DA Capability Report

Pacific Link Housing Ashton

23-25 Ashton Avenue, The Entrance NSW 2261

Reference: N240113

Figure 5 - Length of Public Corridors

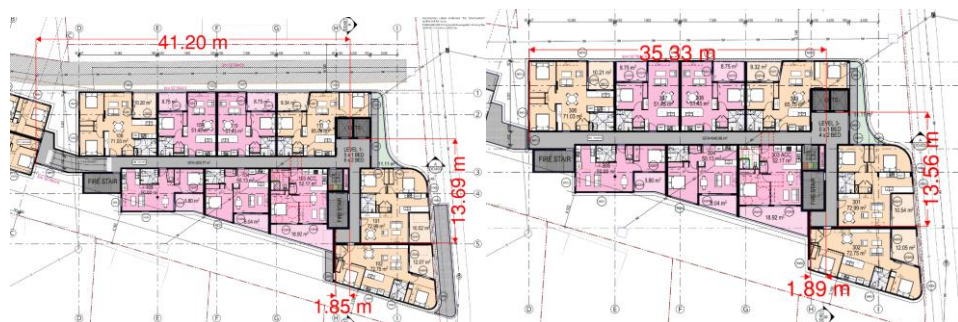
The public corridors on all floors exceed 40m (approx. 57m worst case level 1 & 2). The DtS measures requires dividing the corridors into two with a connecting smoke proof wall and smoke doors swinging in both directions including a minimum 400mm smoke reservoir on both sides.

The design team has indicated the intent to seek a Performance Solution for this aspect. Fire Engineer is to confirm suitability or smoke doors in the accordance with the requirements of this Clause is required.

Architectural has advised this is intended to be addressed within a Fire Engineered Strategy.

Figure 6 - Inter-allotment Boundaries

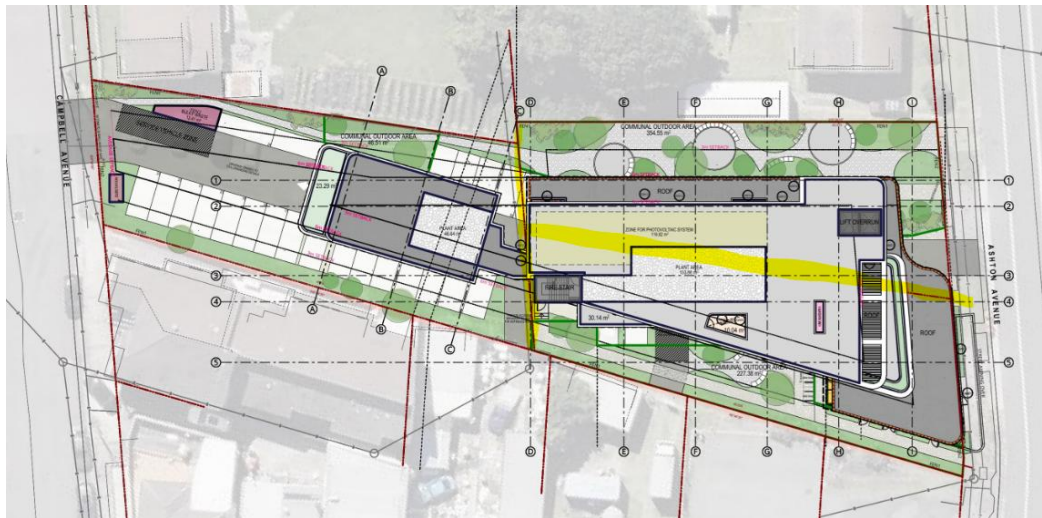
The building is currently split via inter-allotment boundaries which is considered a fire source feature under Specification 5.

The design team have indicated the intent to amalgamate the lots boundaries as highlighted below.

Figure 7 - Temp Bin Exposure to FSF

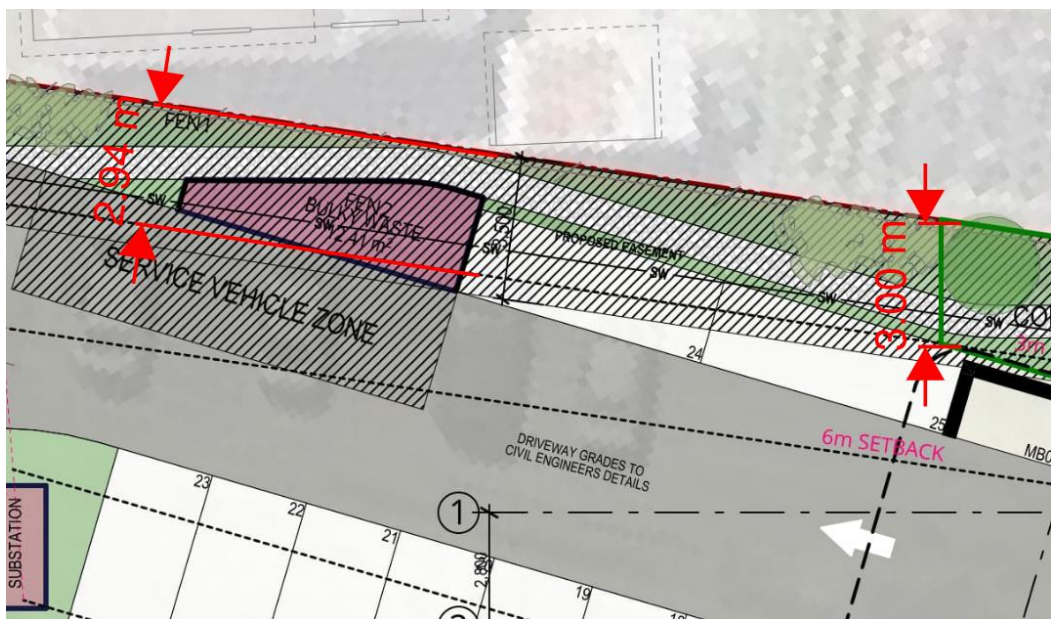
The external wall of the GL bulky waste is located <3m from side boundary and required FRL in accordance with Spec 5 / FER (120) where enclosed room. Architect advised will be palisade fence and open to the sky not requiring FRL.

The storey above dashed line depicts more than 3m from FSF. Compliance achieved to be monitored as design progresses.

Figure 8 – Bike Rack, Storage, & Pump Room more than 3m from FSF

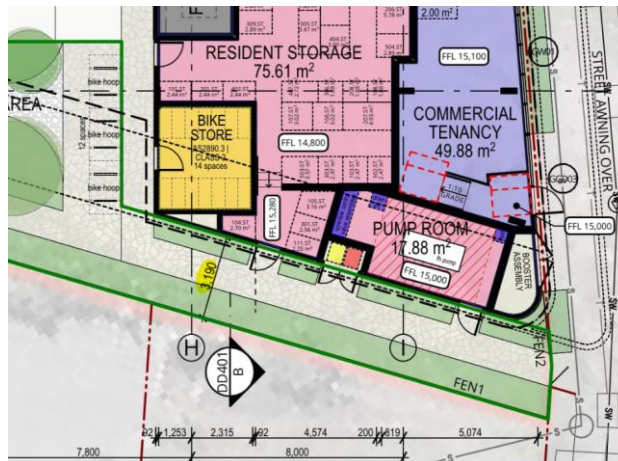
Updated plans depict the external wall of bike rack, resident store and pump room being more than 3m from side boundary which does not require fire rating in accordance with this Clause where non-loadbearing, however does require FRL 60minutes for discharge of fire isolated stairs see BCA D2D12. For loadbearing FRL fire engineer to advise where varied from Spec 5. Architect advised likely concrete or block to be addressed in design development.

Figure 10

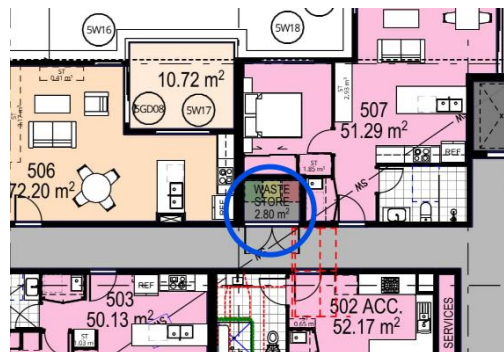
- + Class 2 lobby / public corridor on ground level requires separation in accordance with Spec 5 except where varied by FER.
- + Class 2 bounding walls (between SOU or between SOU and public corridor / lobby) are to be FRL 90-minute loadbearing or FRL 60 minute nonloadbearing. Fire rating plan to be provided including waste\ stores

Figure 11 – Ground Level

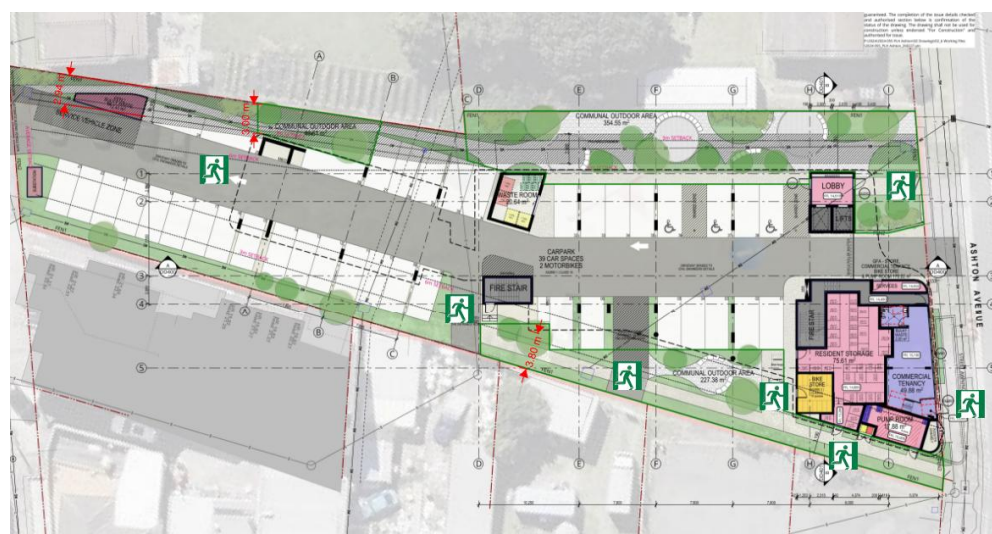
Comment: The number of exits provided complies in this regard. Exit doors shall be depicted within fire isolated stair shaft on each storey, as well as along Commercial tenancy and services room.

Note. the exit at ground level is the point in which open space is reached, any overhead covering shall be depicted on plan.

Indicative exit locations for each storey depicted below.

Figure 15 – Extended Travel Distance from SOU's

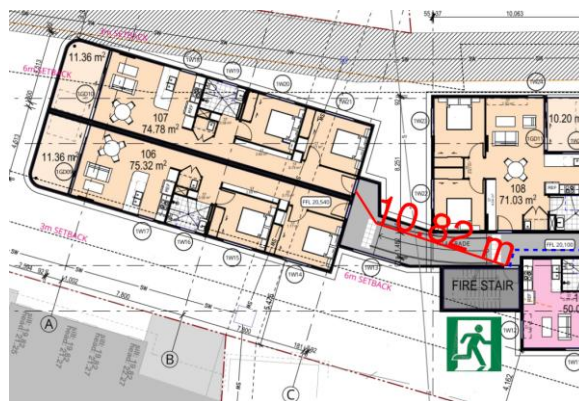
Typical scenario below whereby travel is in excess 6m to point of choice (D2D5). Noting FRNSW do not support (S18C3) AS2118.1-2017 sprinkler concession, due to the mixed use of the building. Design team have indicated intent to seek performance solution for extended travel.

Fire engineer to confirm suitability, below listed areas exceed DtS limitations. Confirmation is required whether a fire engineered strategy will address extended travel distances from SOU.

- + Up to 11m (worst case) in lieu of 6m to nearest exit on level 1 and level 2. Fire engineer to confirm suitability.

Figure 16

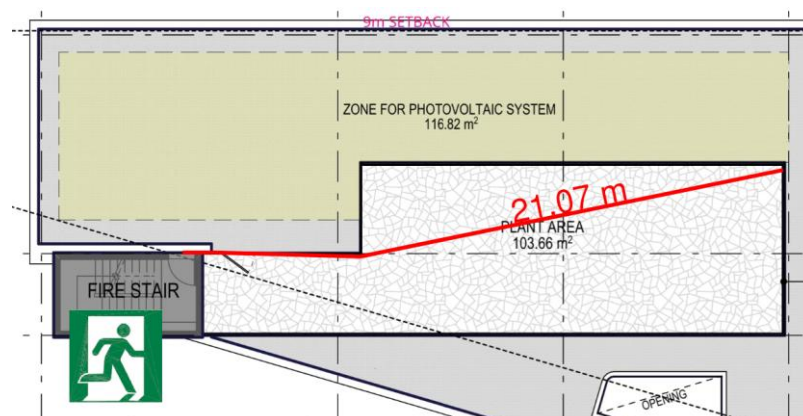
- + Up to 23m in lieu of 20m from roof plant area. Plant location plan to be provided to confirm, architect advised redesign to DtS once plant equipment is an option.

Figure 17 – Subject Staircases

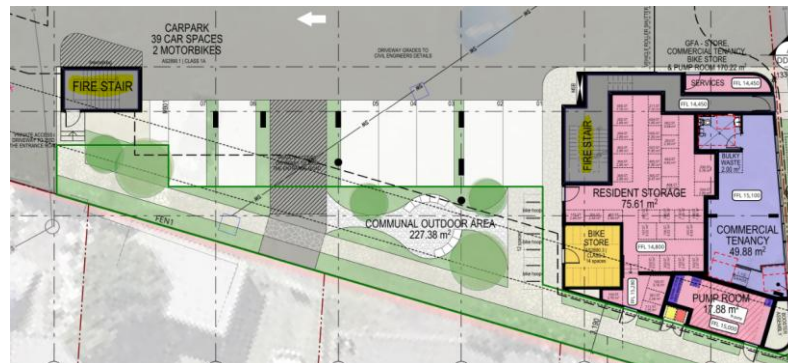
Compliance readily achievable, client to confirm if any of the exit stairs are intended to serve as general communication stairs between storeys.

Any general circulation stairs will require handrail both sides, TGSI's on landings and balustrades with vertical rails and no gaps exceeding 125mm. All fire isolated stairs are described as fire stairs only therefore not deemed general circulation as part of this assessment or until confirmed otherwise on plan.

Figure 19 – Travel Via Fire Isolated Exit

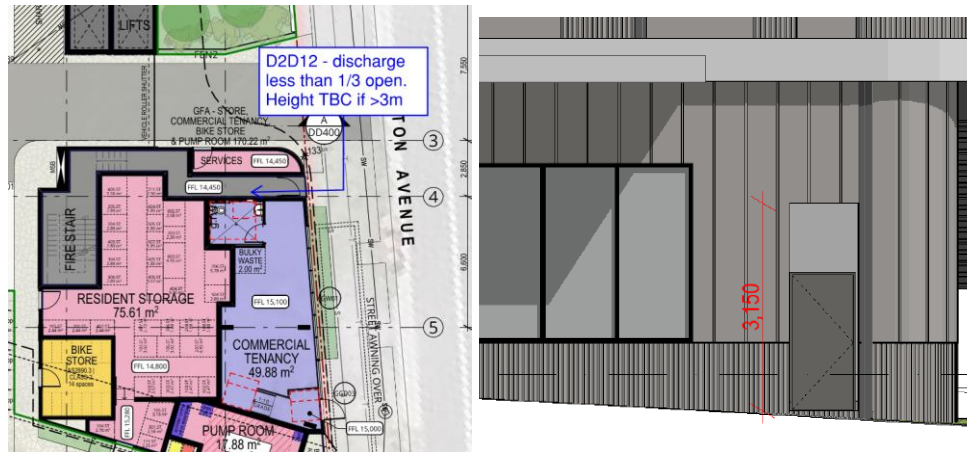
All fire isolated stairs require the final exit door to be depicted on plan. Updated elevations indicated more than 3m height unobstructed height.

Fire engineer is to review discharge into area less than 1/3 open for suitability for inclusion by way of fire engineered strategy.

Figure 20 - Discharge Paths Exposure to be protected.

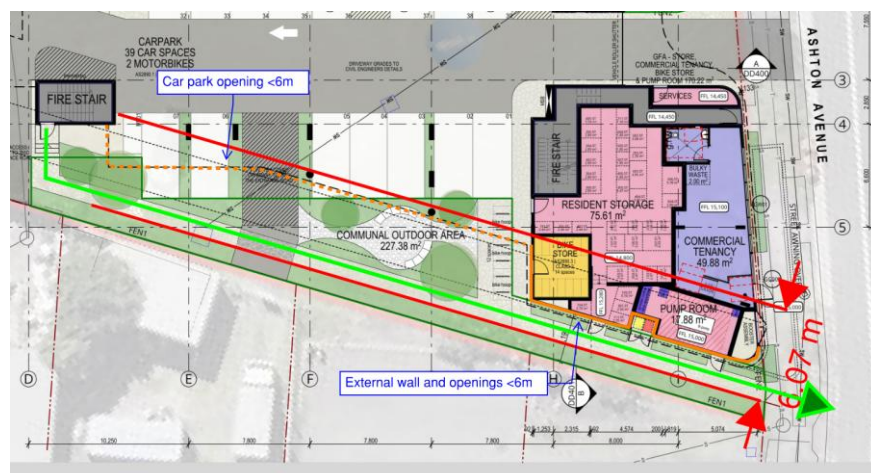
Indicative path of travel fire rated external wall location where discharge path <6m from external wall and car park openings requiring protection for distance of 3m in height depicted below. Particular attention is required for any openings which would require fire rating in accordance with C4D5, this extends to car park openings.

Confirmation required on plan how compliance will be achieved in conjunction with fire engineer.

Figure 21 - Discharge from Exits

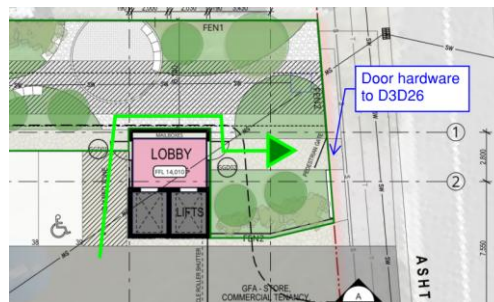
Fire stair doors are configured in a manner that do not open direct to car park requiring installation of bollards to prevent exits from being blocked.

Indicative egress below building line is within travel distance limitations to open space. Confirmation is required however of firm and level surface with gate to have hardware compliant with D3D26. Architect advised will be addressed in detailed design.

Figure 22 - Egress Over Allotment Boundary

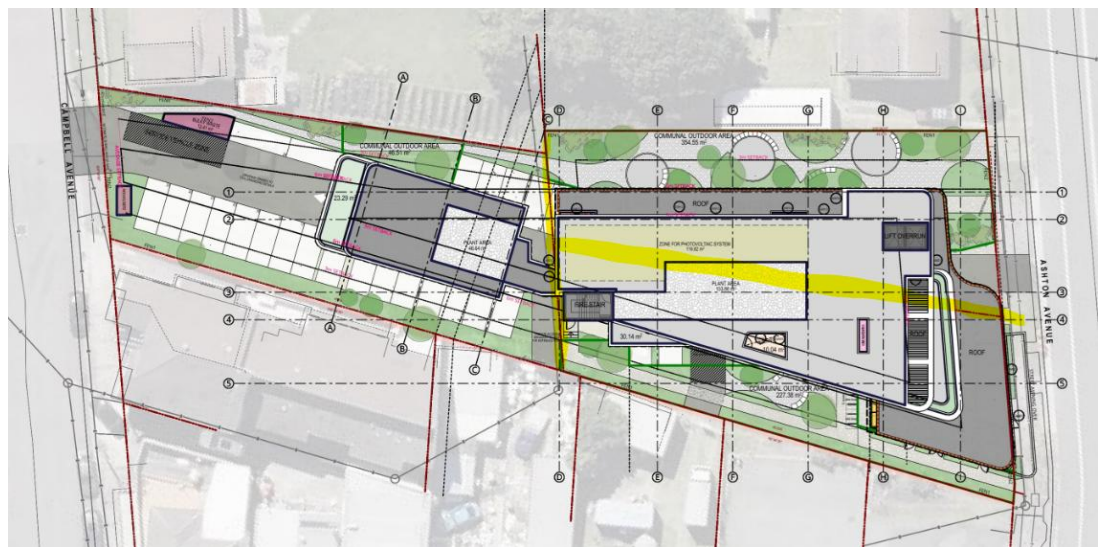
The design team have indicated the intent for lot amalgamation for below highlighted plan inter-allotment boundaries (yellow above) which would be DtS approach.

Figure 23

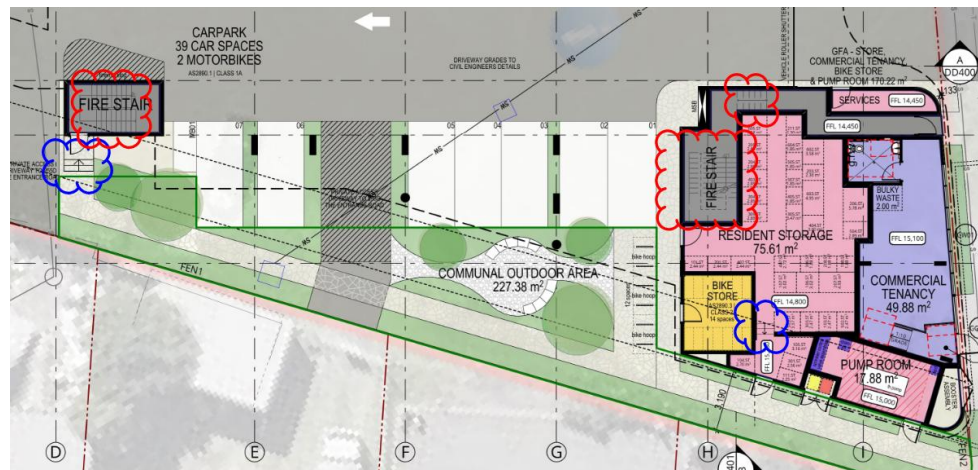
Stairs listed as fire stairs have been assessed as such and are not permitted as general circulation use. Architect shall depict handrail to one side as required for all Fire isolated stairs (red). Non fire isolated stairs (blue) require handrail both sides. A clear unobstructed 1m is required between all handrails. DDA consultant also confirm nosing and TGSI's for stairs than that fire isolated.

Typical below action in all areas.

Figure 25

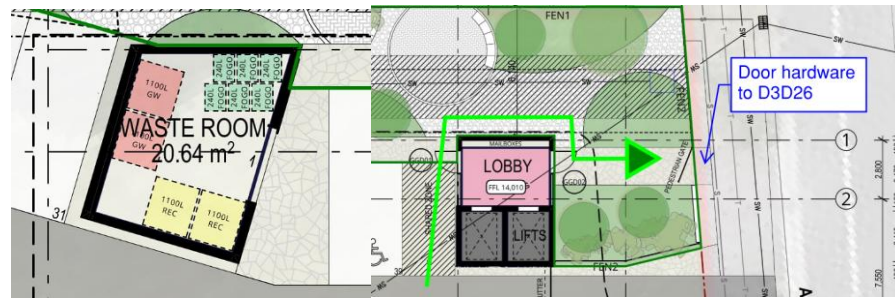
- + Exit doors have been depicted. Confirm with council commercial tenancy exit door can swing over boundary or device to hold open swung against egress is required as per D2.25 (1)(b).
- + The roller shutter serving as vehicle entry point is not an exit for the building.
- + Confirmation the waste room sliding door will have single action D handle from internal. The break-out gate shall have lever action hardware from internal or release on alarm in accordance with D3D26.

Figure 26

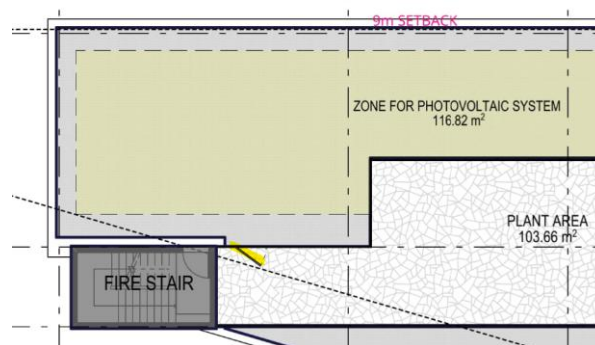
Architect plans to confirm exit door opens direct to plant area. Designer suggested fire door from stair could open direct to OR plant fencing was to wrap around to include entry to fire stair. Future plans to confirm compliance.

Figure 27

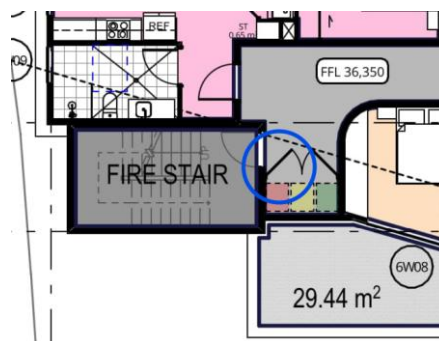
Waste store-rooms to have bounding construction and doors protected requires design development as to not obstruct access to exits.

Figure 28

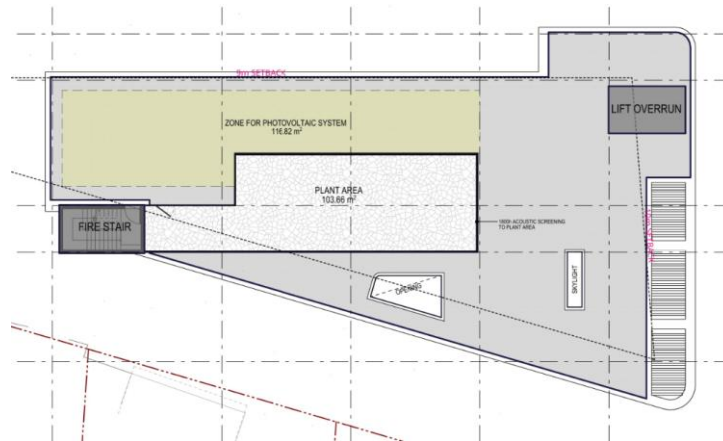
Comment: Confirm proposal of any current or future provision Electrical Vehicle charging (EV). Indicative solar panels proposed for roof shall be included within FER trial design as hazard.

Figure 32 – Laundry Facility

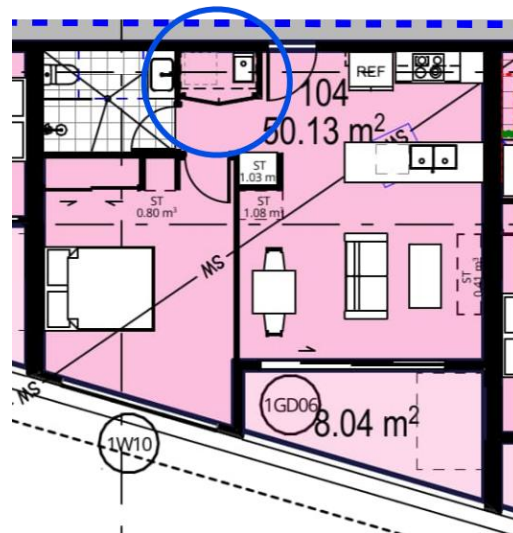
- + The commercial building has single accessible unisex facility which can cater up to 10 persons. Confirmation required if this does not meet design intent.
- + Assumption no on site staff for Class 2 part as no reception provided. Confirm if not the case.
- + Laundry facilities including falls to floor waste to be provided within each SOU. Indicative space has been allocated on plan.

Figure 34 – Acoustic Separation

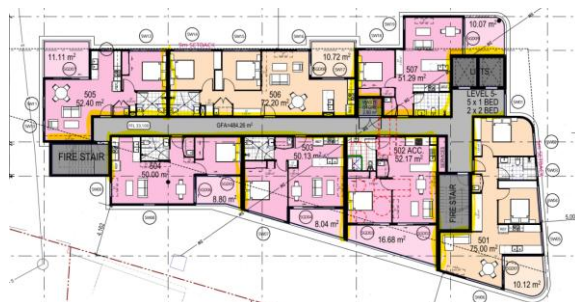
Discontinuous construction (F7D4-2) is required in accordance with BCA F7D6 where SOU are to be acoustic separation by discontinuous construction from lift shaft or kitchen typical yellow highlighted below to be actioned throughout including acoustic rating of bounding construction.
